**REVISED STAFF REPORT - DESIGN REVIEW E
FINDINGS AND RECOMMENDATION**

FILE NUMBER: DRE/MIS/TR 18-26000352

LOCATION: 740 SE 182nd Ave., Portland OR 97233 and R233502220

PROPOSAL: Type III Design Review E for the construction of four multifamily buildings with four stories (Buildings A-D); one multifamily building with three-stories (Building E); one single-story building for accessory uses (Community Center); dedication of right of way for new streets (SE 185th Avenue and future east/west street); Type III special purpose overlay boundary revision to modify the open space overlay; Type II Tree Removal; open space improvements; and associated parking and site improvements.

EXISTING OPEN SPACE OVERLAY BOUNDARY

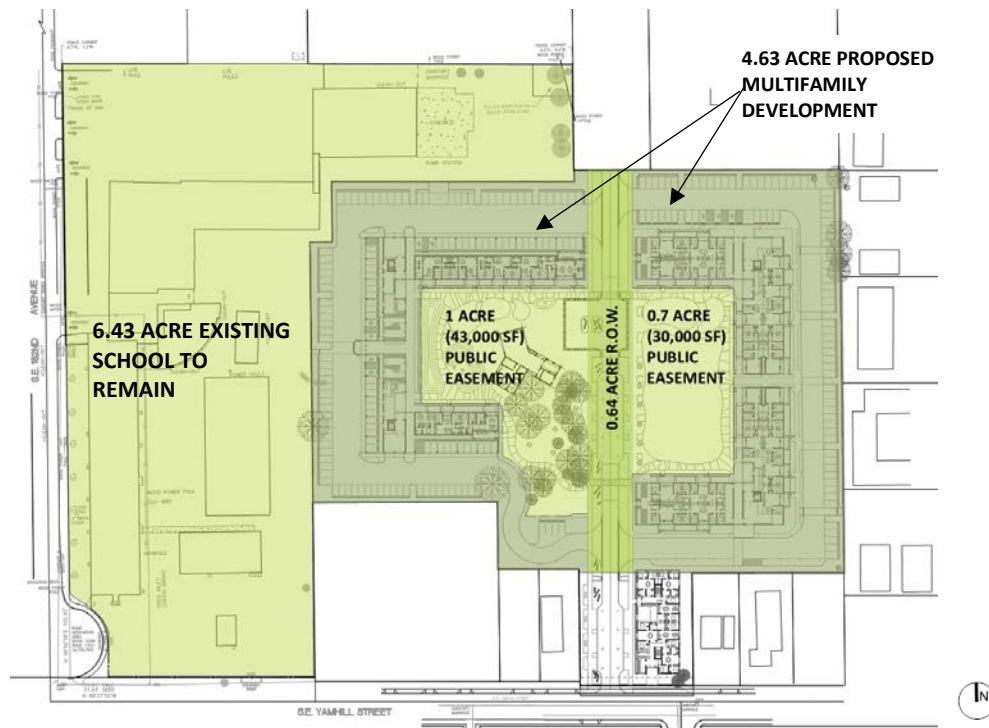
PROPOSAL: The proposal includes an application to revise the boundary of the Open Space Overlay District. Presently, the size of the overlay on the subject parcel is 13.37 acres. Sheets G.9.1 - Proposed Open Space and L6.0 - Open Space Easement illustrate the proposal, which will reduce the open space overlay from 13.37 acres to 8.10 acres. The removal of 5.27 acres of open space overlay is a 39 percent reduction in area. The project will develop approximately 640 linear feet of SE 185th Avenue and develop a 224-unit apartment complex with privately-owned open space accessible to the public.
